# Tech Information

## Derby cover gasket

## Stock derby cover gasket modification

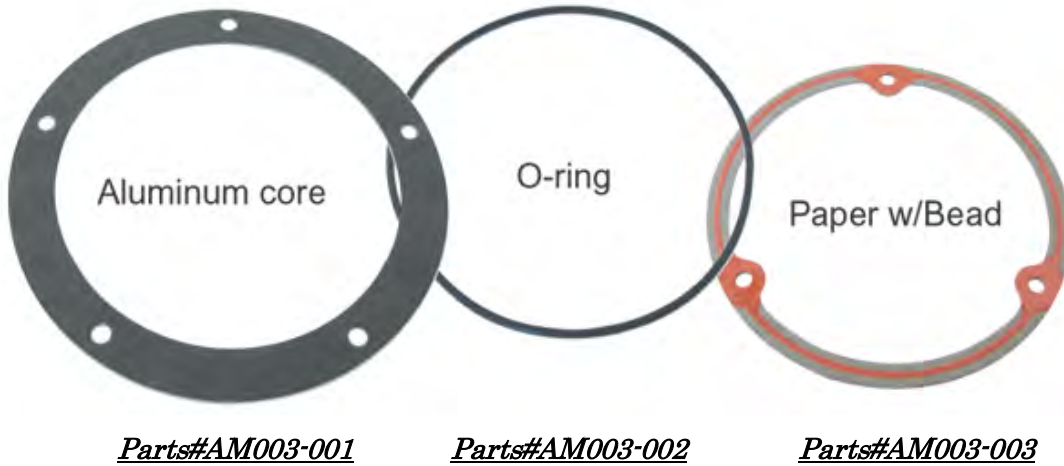
Use O-ring type derby cover gasket or our **"Our special Gasket (Parts#AM003-001)"** when installing VP clutch or cut inside derby cover gasket of Harley-Davidson made (part#25416-99C), because weight of VP clutch will be hit to derby cover gasket. (See picture)
